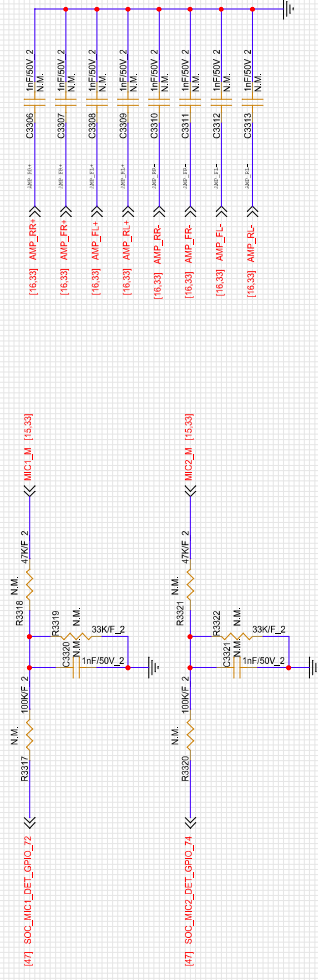
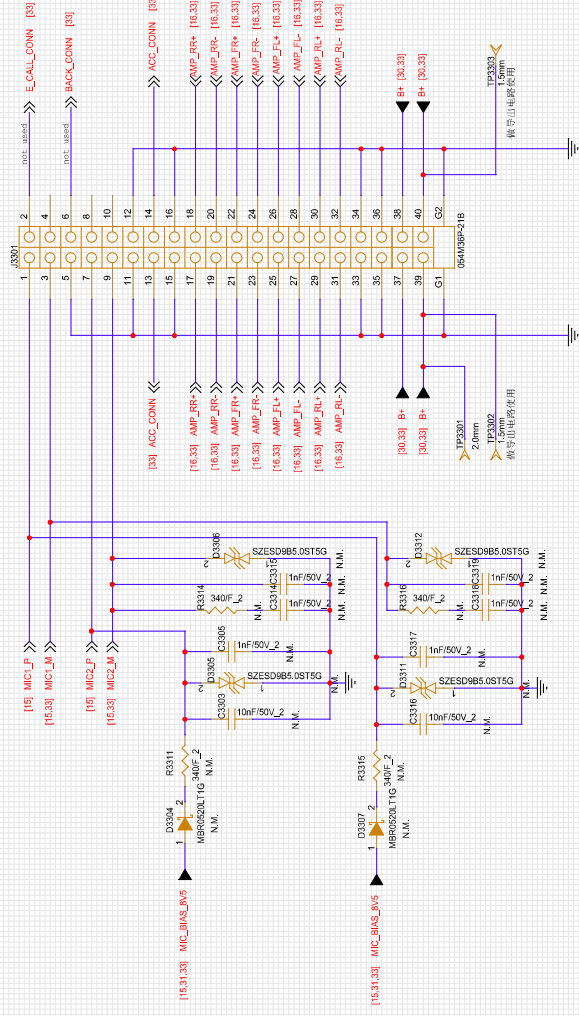
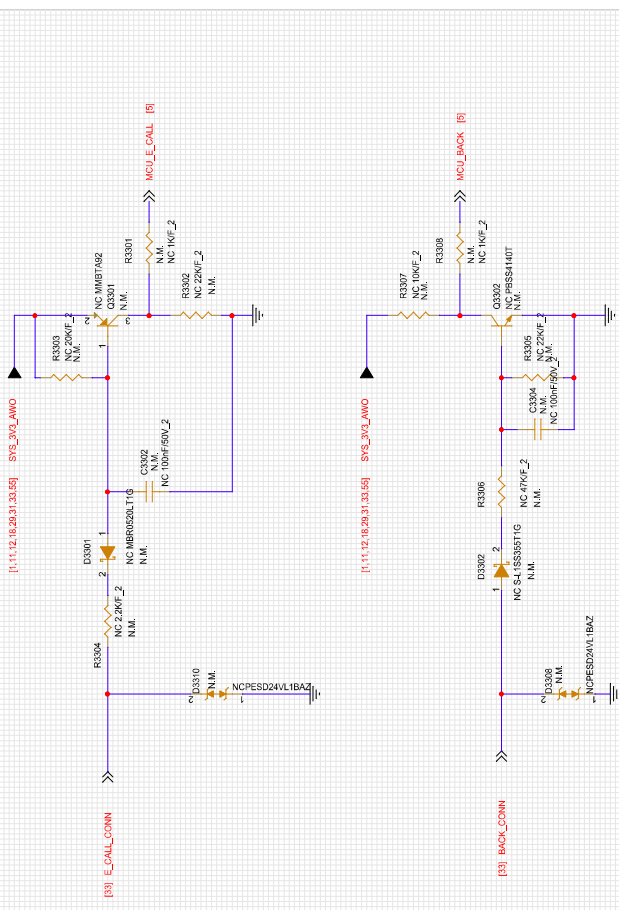
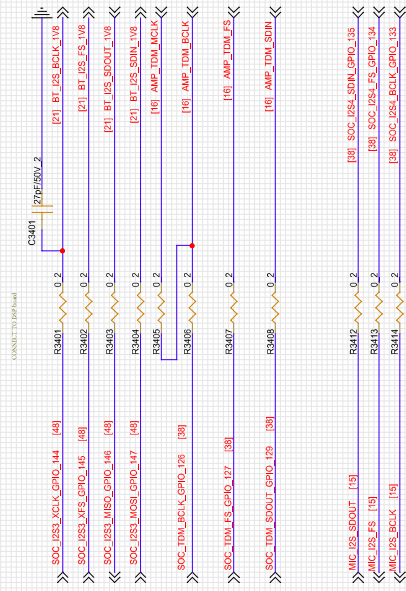
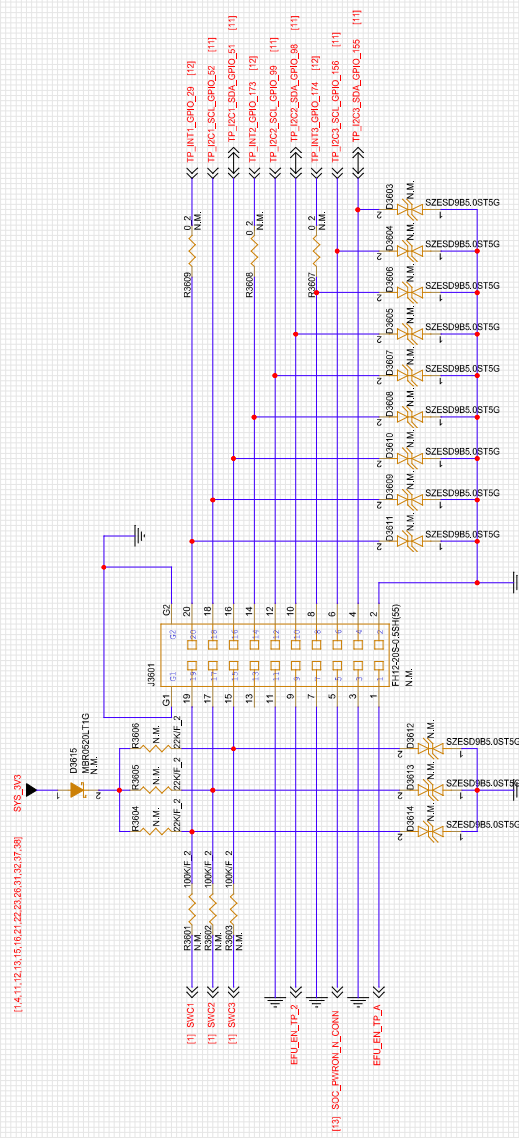
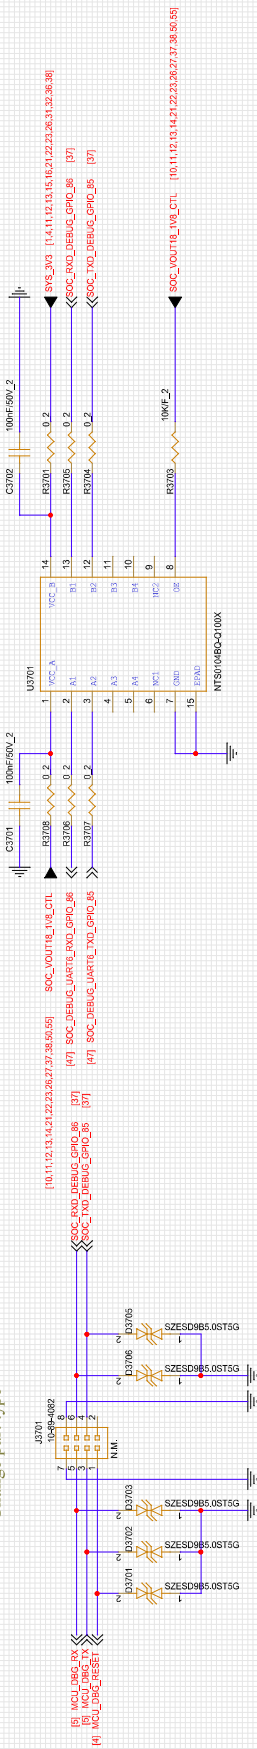
Change part type

U2L
QAMBI55P_B0_16758_1

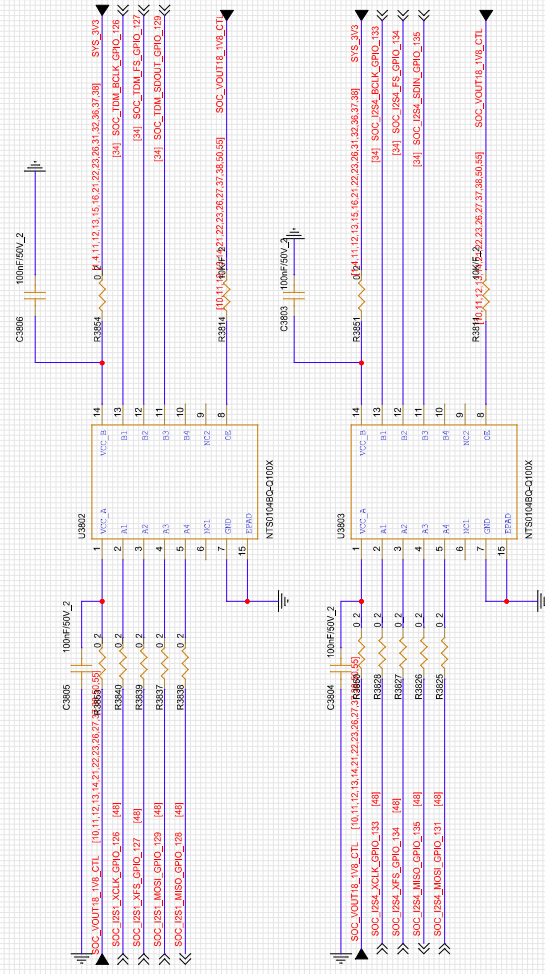
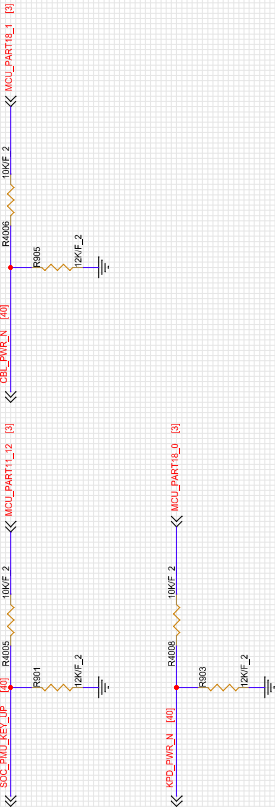
Add camera power control

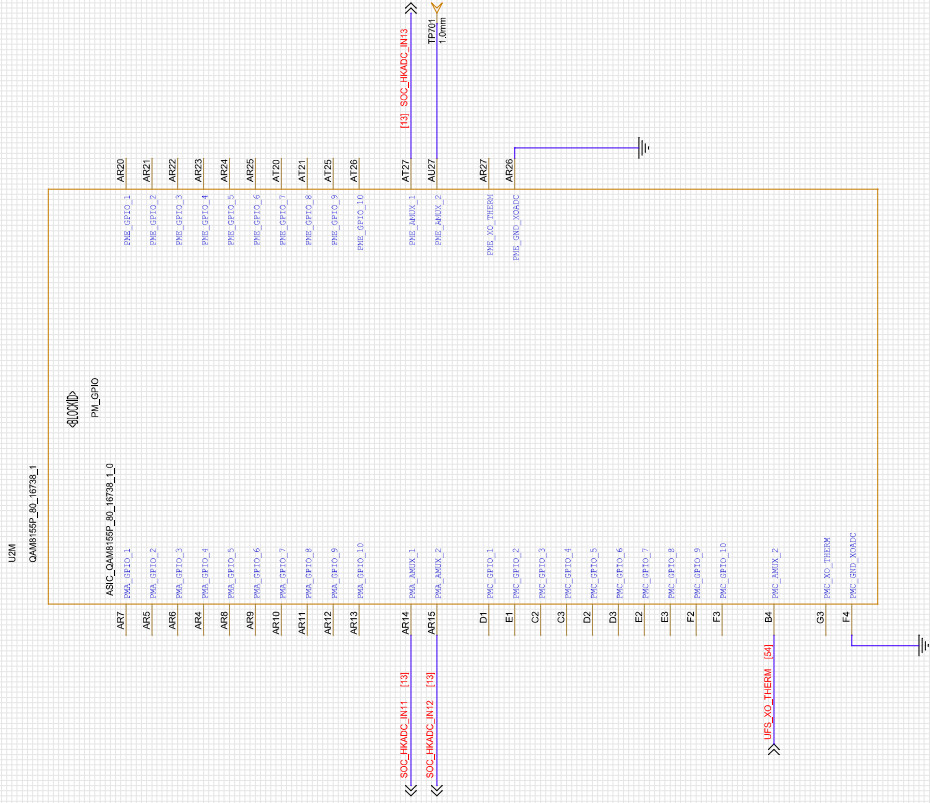
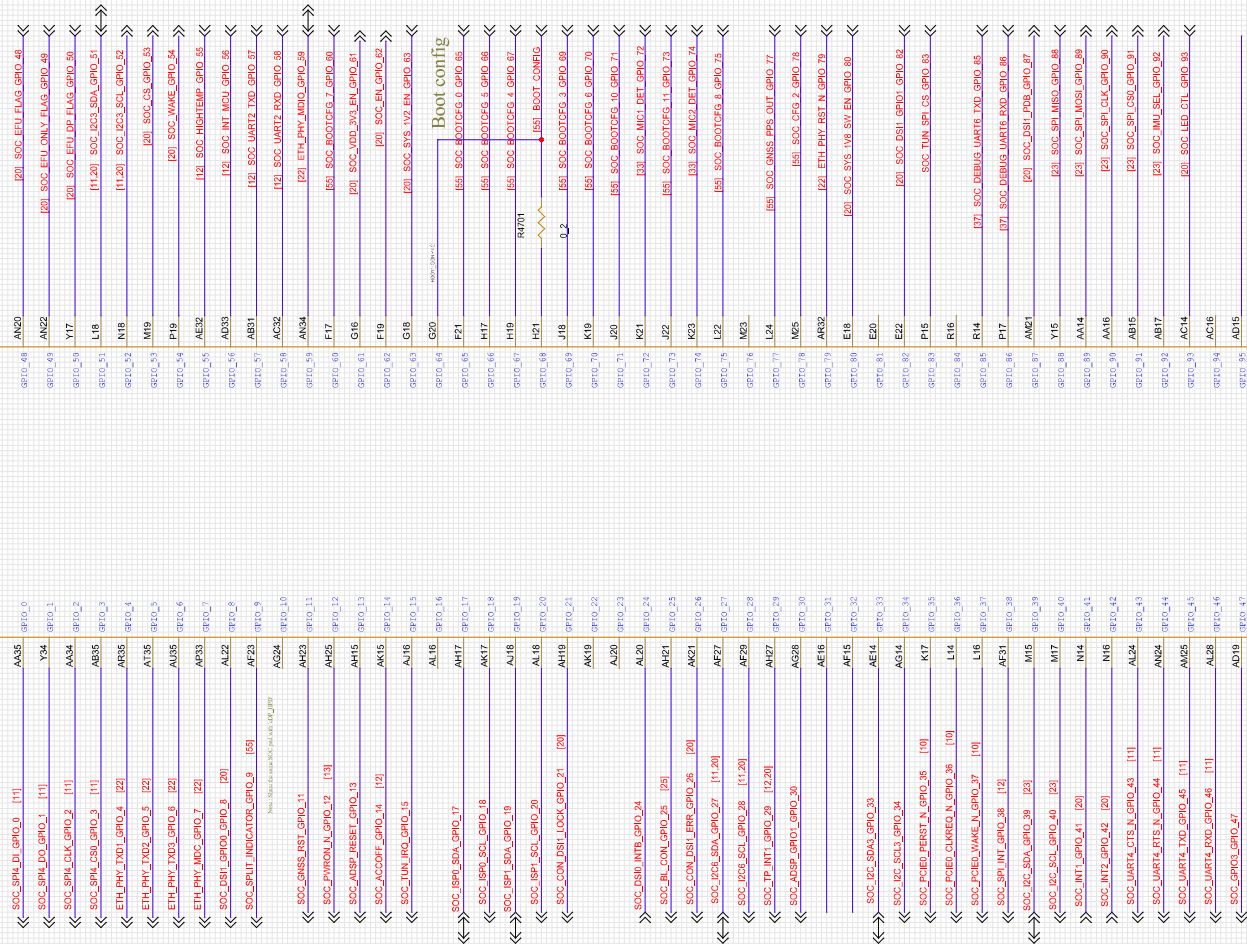
Add Screen-split indicator

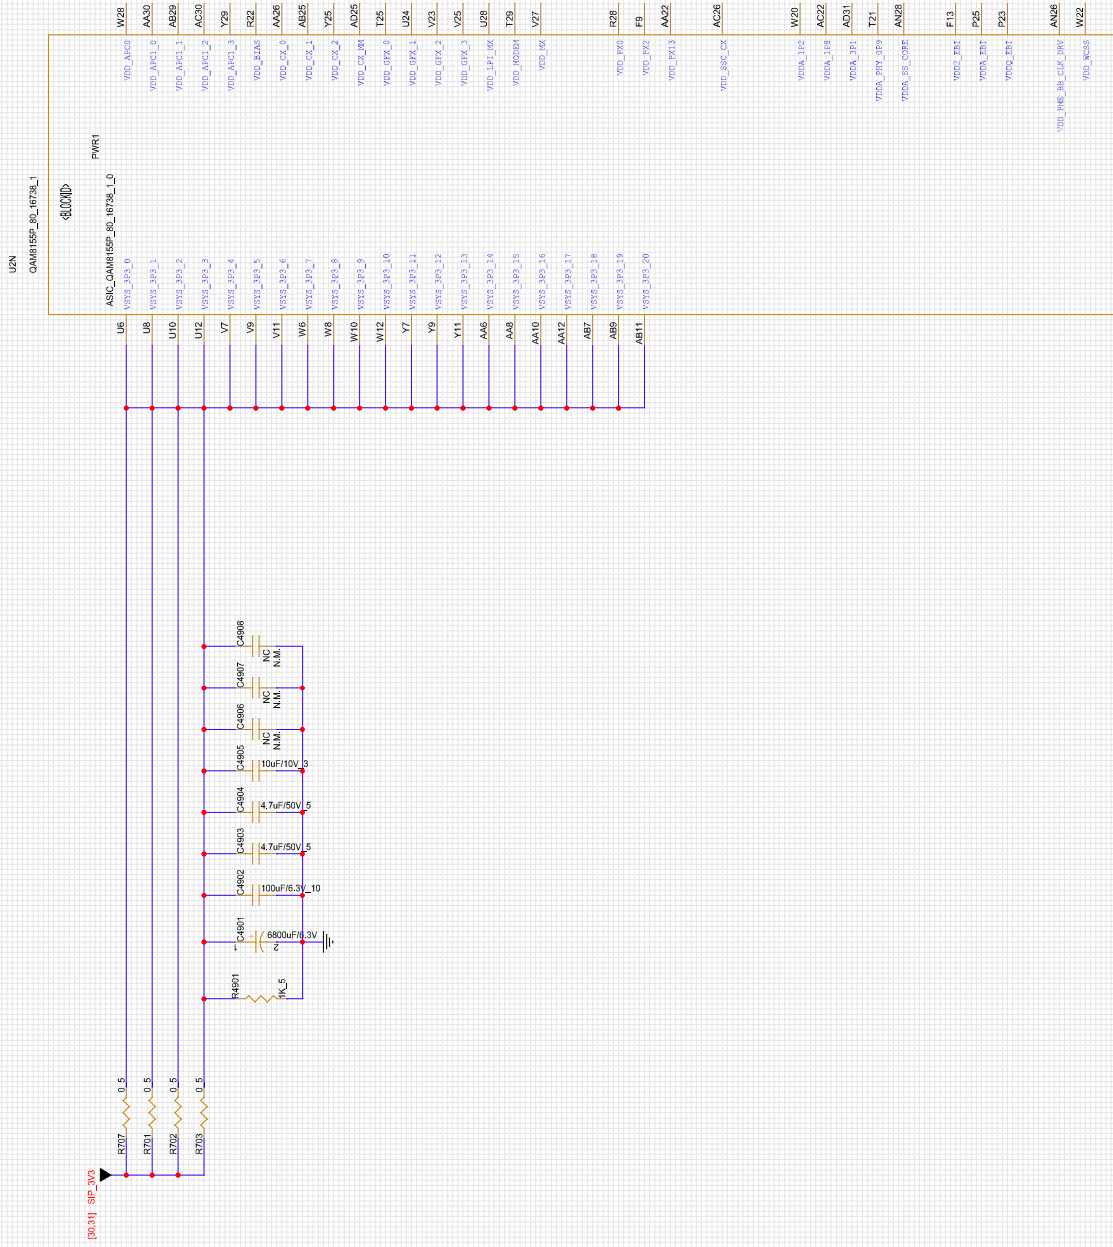
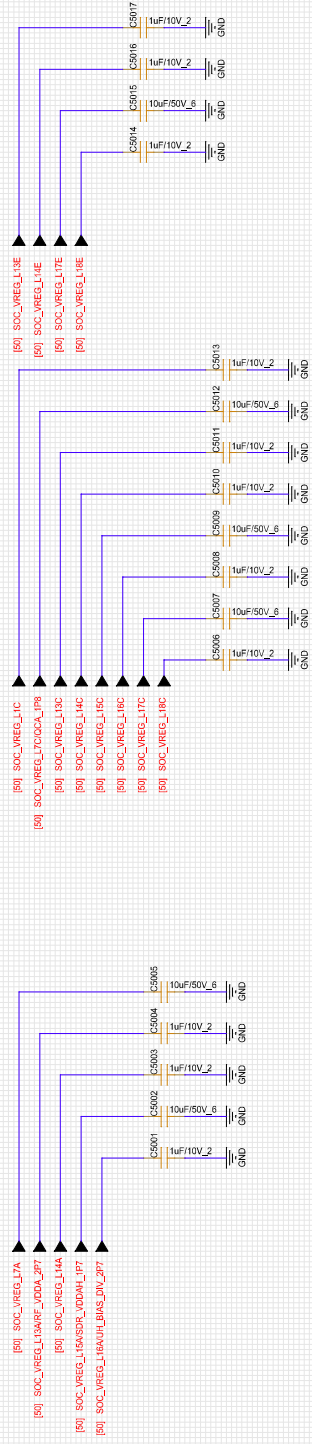
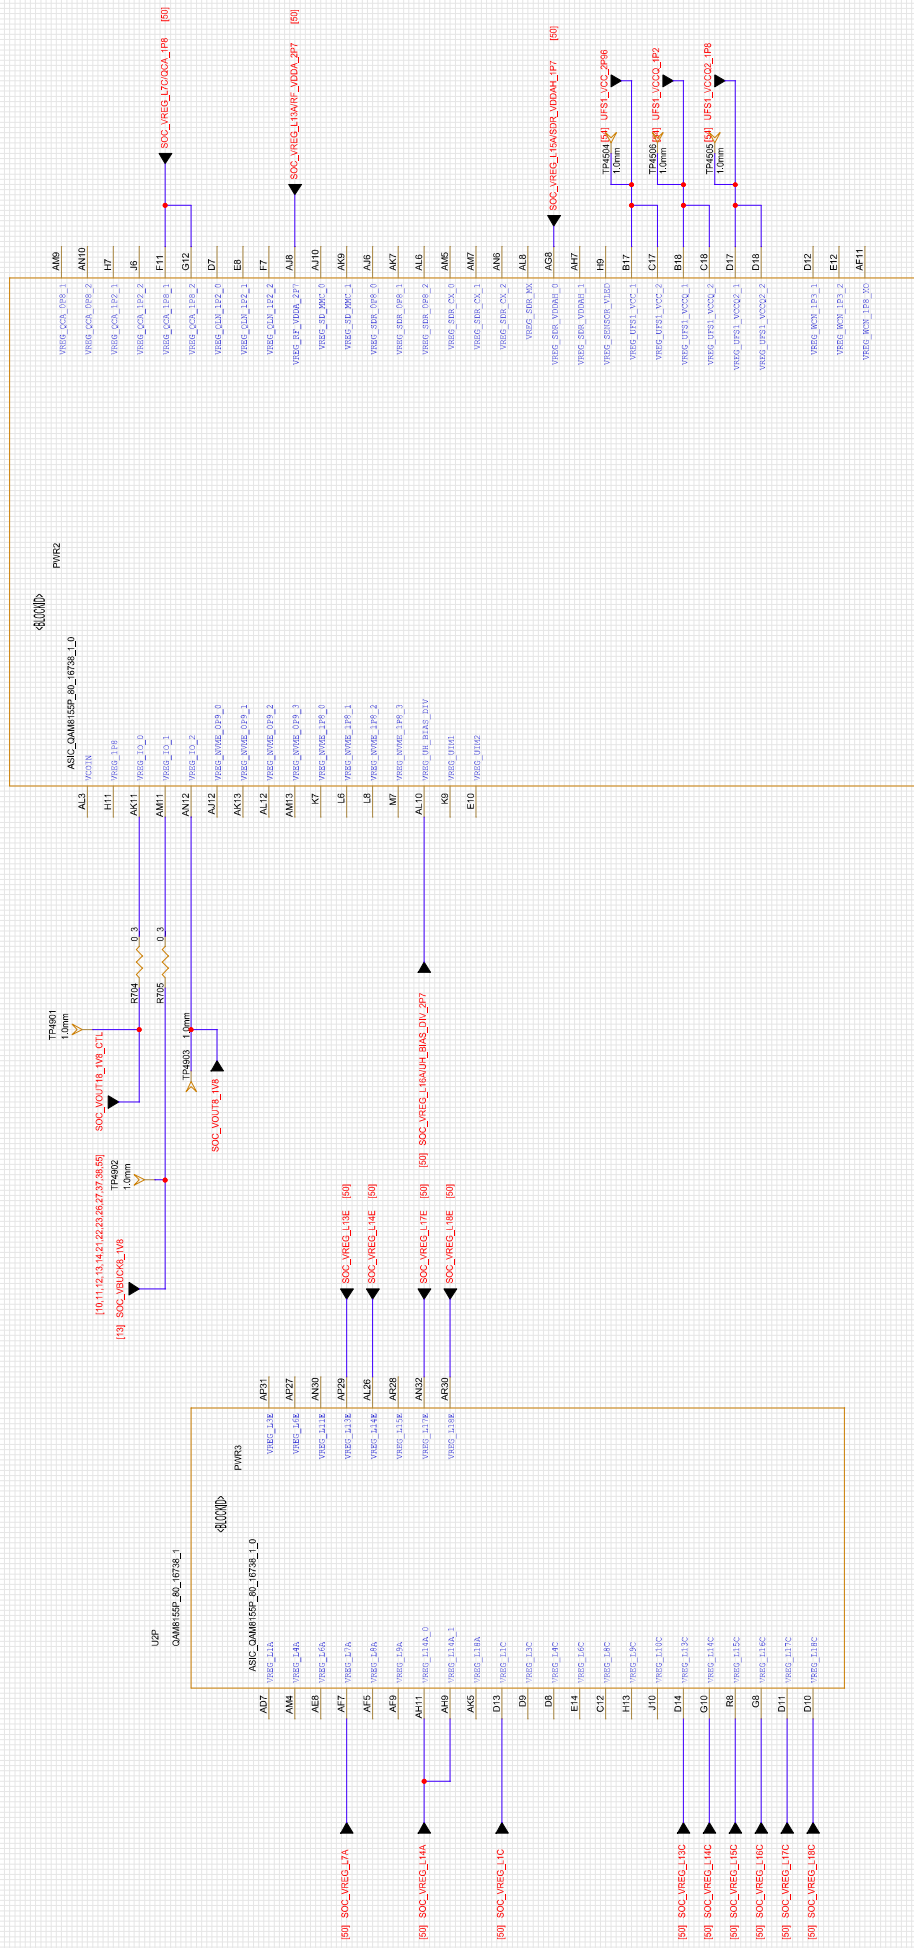
PDN compliance
